Model	N810	Volt/Hz	Date of Modification	Serial Number
Modified Article	Parts Catalog			
Reason for Modification	Parts catalog correction

MODIFICATION BULLETIN NO. 3

ISSUED ON: July 31. '93

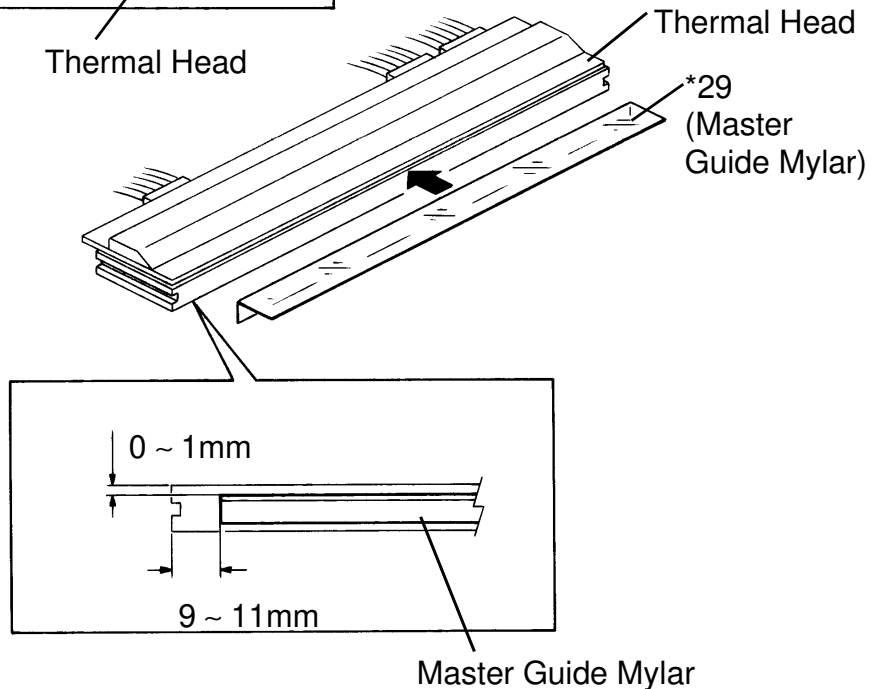
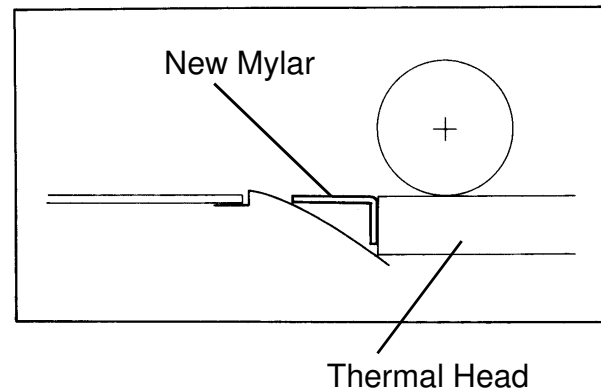
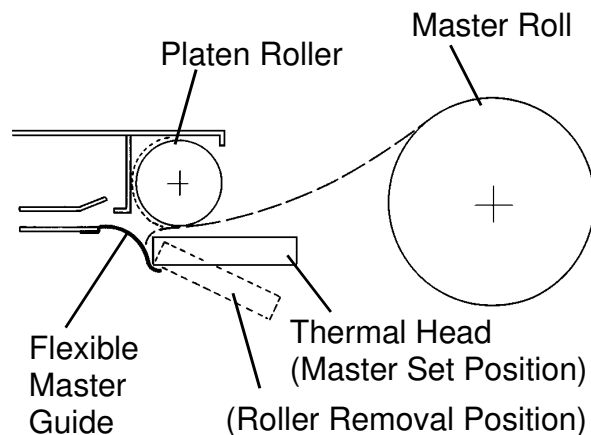
There are two positions for the thermal head release lever: one is to set the master and the other is to remove the platen roller. If an operator mistakenly uses the roller removal position for the master set, the leading edge of the master tends to hit the flexible master guide as shown below. As a result, after the master cut button is pressed, the master will wrinkle and wrap around the platen roller. To guide the master smoother, a strip of mylar has been added on the thermal head.

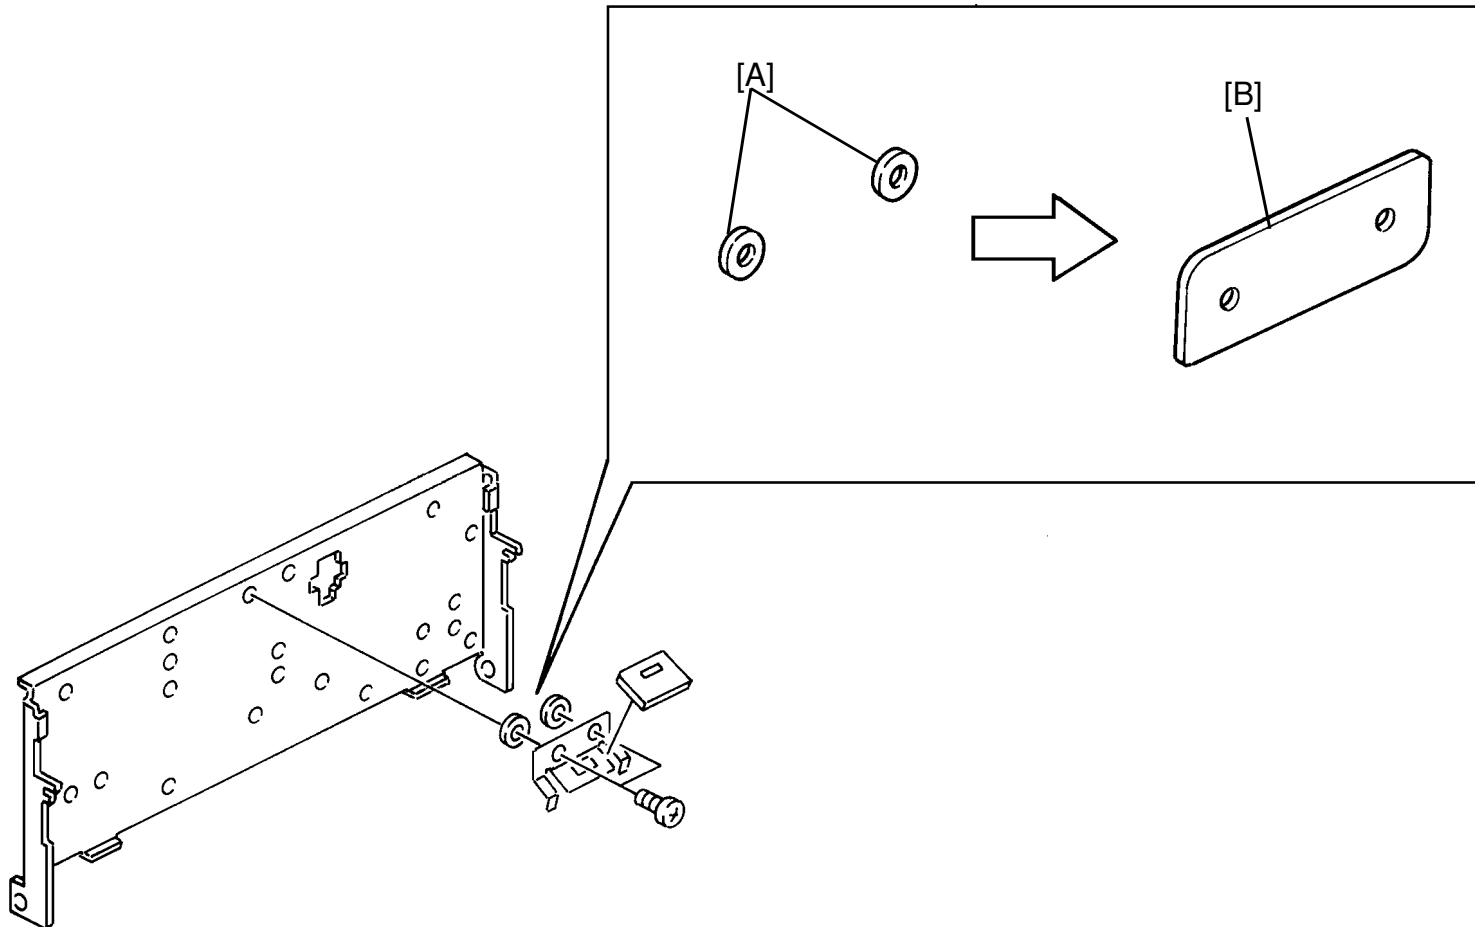
To facilitate assembly, the ADF friction pad spacer has been changed from two washers [A] (These washers are not listed on the parts catalog, but being installed from the 1st production.) have been changed to a thin square plate [B].

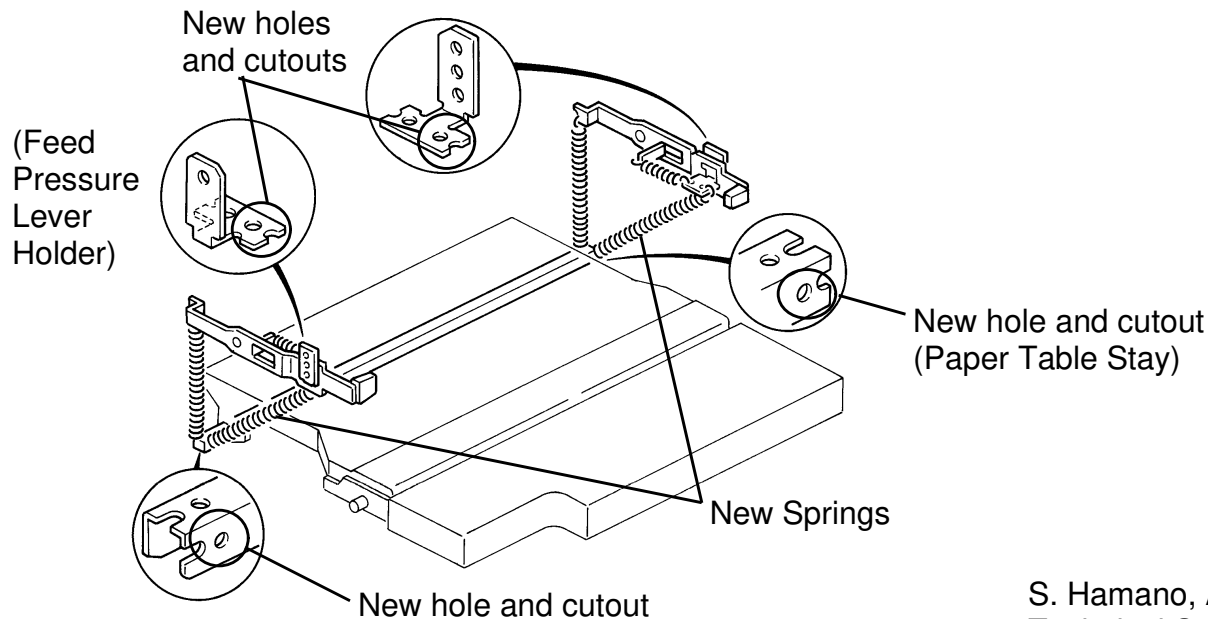
With the current paper table lifting mechanism, paper misfeeds may occur when the pressure adjustment levers are in the upper position (the weak paper feed pressure position) and 500 sheets of standard paper (80 g/m² or 20 lb paper) are set on the paper table. To ensure the paper stack capacity even with the weak paper feed pressure position, two springs have been added. To hook the springs, holes and cutouts have been added to the paper table stay and feed pressure lever holder as shown below.

NOTE: Due to this modification, the pressure adjustment levers have been returned to the upper position in the factory (this is now the factory setting). As in the past, set the levers in the lower position when paper misfeeds occur and return them to the upper position when paper multifeeds occur.

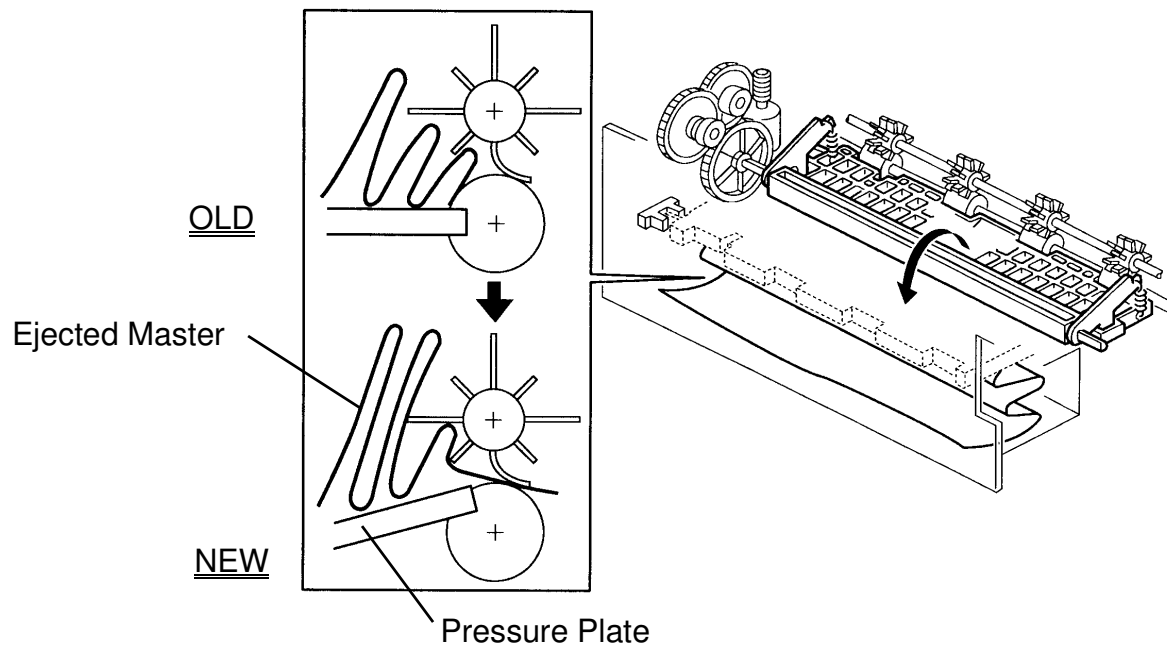
It was found that the ejected master can be fed by the eject rollers more smoothly if a pressure plate is placed just below the upper eject rollers. (See the illustration below.) With the current pressure plate position, the trailing edge of the ejected master tends to be caught by the lower eject rollers.

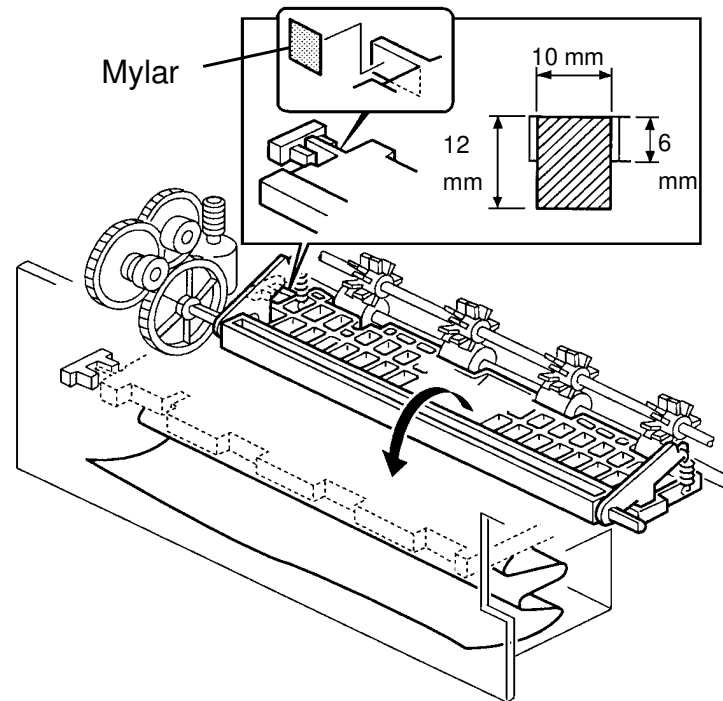
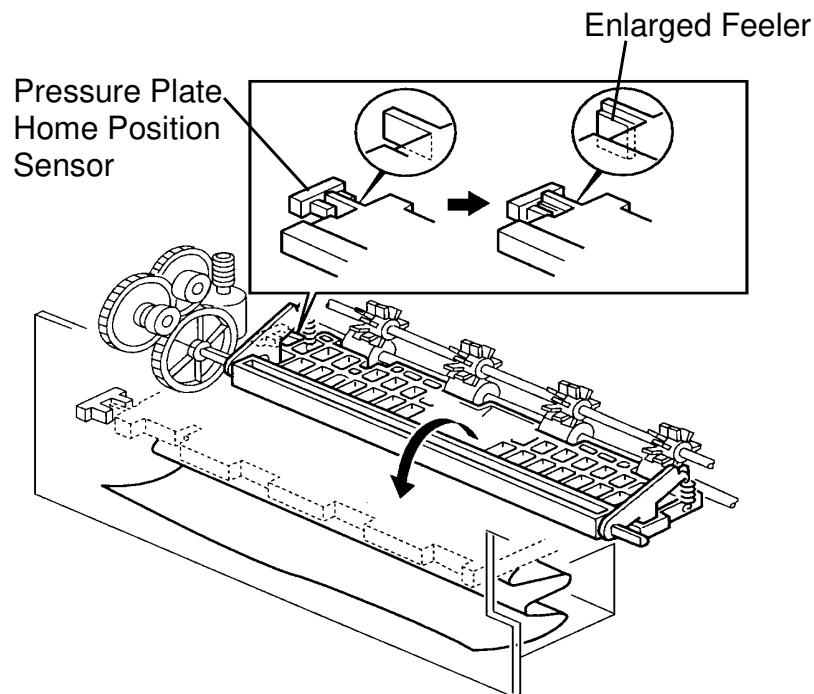
To enable the pressure plate to stop slightly higher than the current position, the feeler in the pressure plate, which is detected by the pressure plate home position sensor, has been enlarged as shown below left. The enlarged feeler is detected by the sensor earlier than the current type, causing the pressure plate to stop just below the upper eject rollers.

For the field units, the same effect can be obtained by attaching a strip of mylar on the feeler (see the illustration below right).

1. The mylar must not be transparent and must be detected by the pressure plate home position sensor.
2. The size of the mylar must not exceed that indicated in the illustration. If the mylar is too large, the pressure plate will stop at too high a position and will interfere with the ejected master transportation.

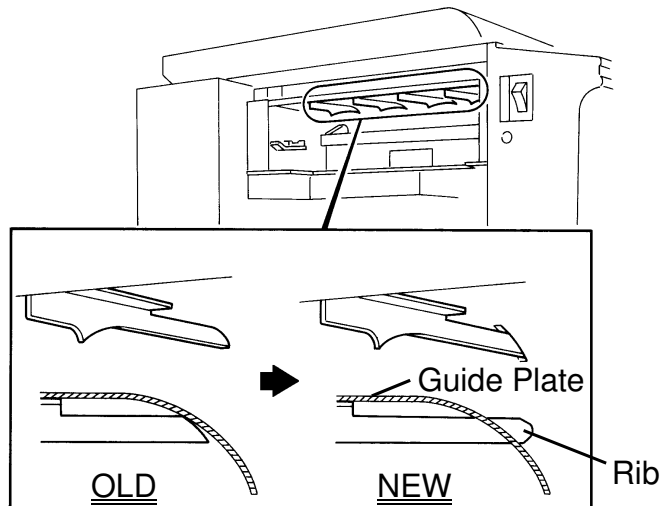
To prevent master eject jams, the ribs fixed to the guide plate have been changed as shown below. For details, refer to RTB-004.

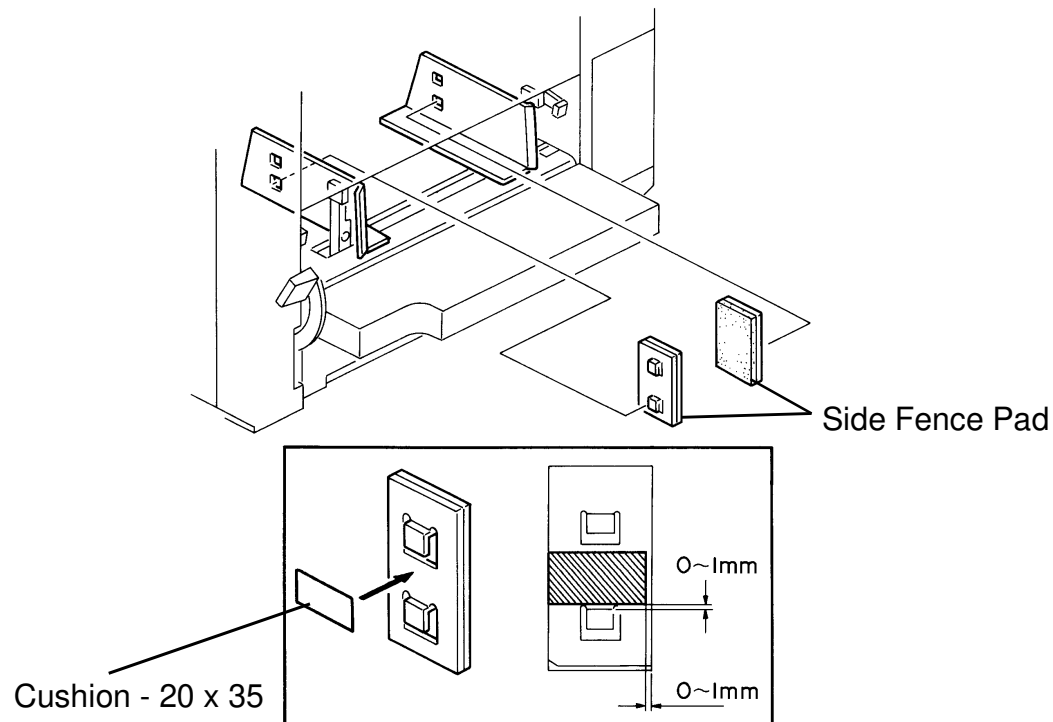
To fit the side fence pads (accessories of the machine) to the side fences firmly, a cushion (C2175017) has been added to each side fence pad as shown below. The new side fence pad (C2175019) includes the cushion.

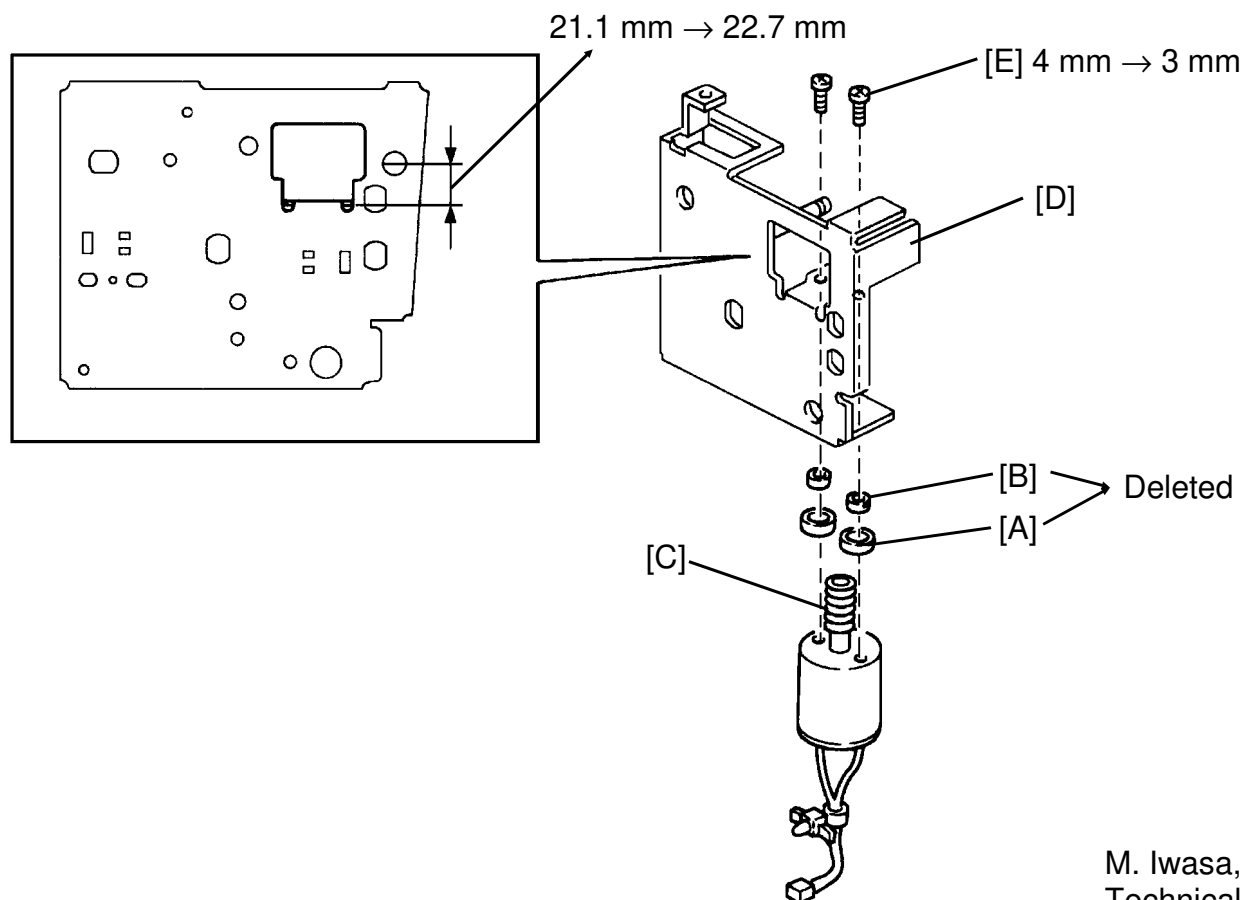
As a permanent solution of the modification described in MB-07, the material of the pressure motor's worm gear [C] has been changed from a combination of metal and plastic to metal.

Due to this, the right side plate [D] has been returned to the previous type, and the bushings [B] and insulators [A] are no longer used. The screws securing the motor [E] have also been returned.

Drawing No.2

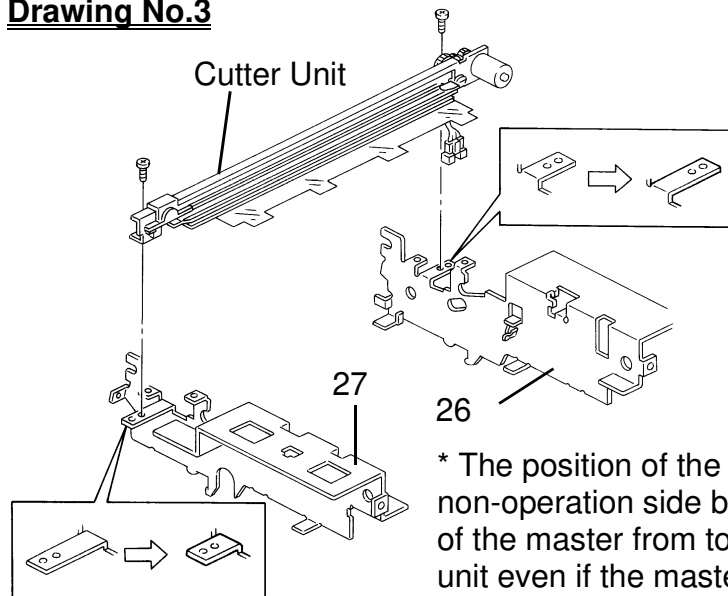
* Step 4 has been added to instruct the operator to rotate the master roll back slightly before setting the platen roller. This is to prevent creasing of the master.

Drawing No.3

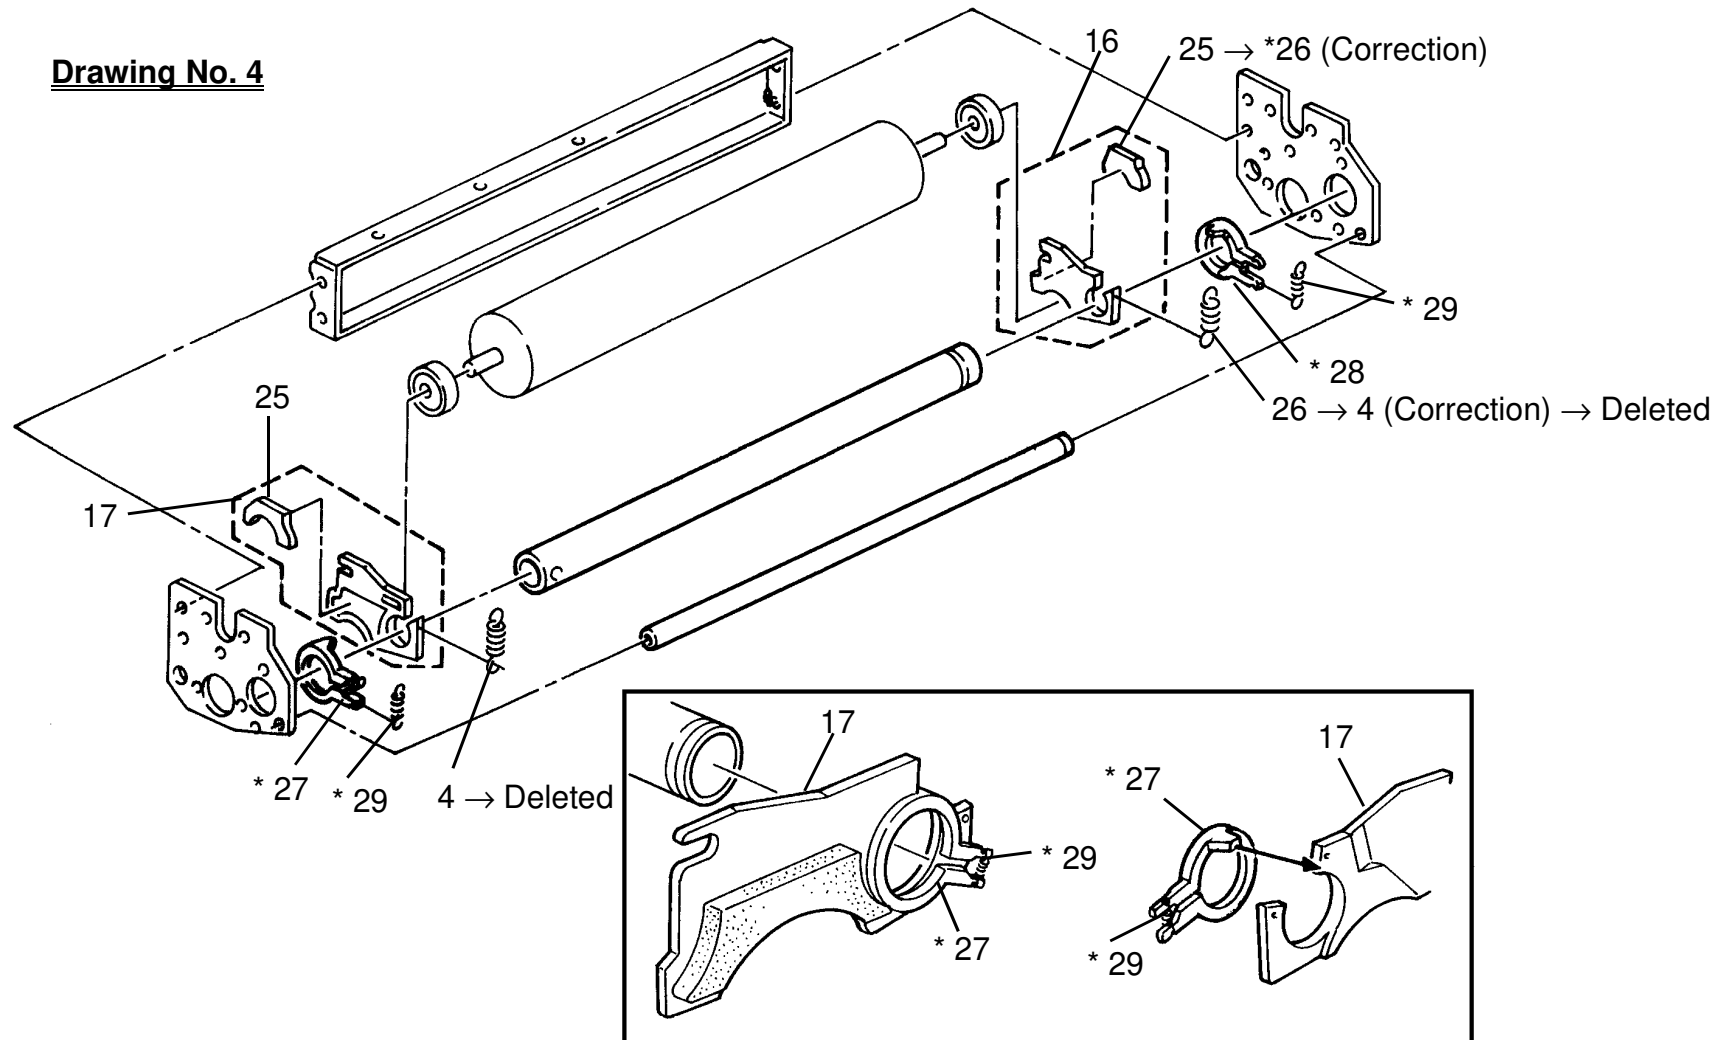
* The position of the cutter unit has been shifted to the non-operation side by 3 mm. This is to prevent the edge of the master from touching the guide plate in the cutter unit even if the master is set at a skew.
